Review of the Rossiter Road and Widcombe Parade Scheme

Widcombe Association
December 2015

ROSSITER ROAD REVIEW

Position for a possible future signal control box with temporary cover.

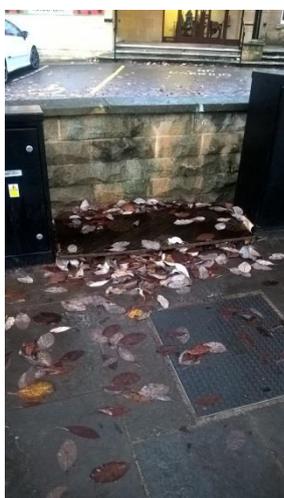
1. Paving generally – not well laid. Edges proud.
2. Pulteney Road north side just before canal bridge – unfinished footpath.
3. Pulteney Road north side – broken paving slabs by Baptist car park (by shop window).
4. In front of Baptist Church. Hole for a possible future signal control box covered by a wooden board.
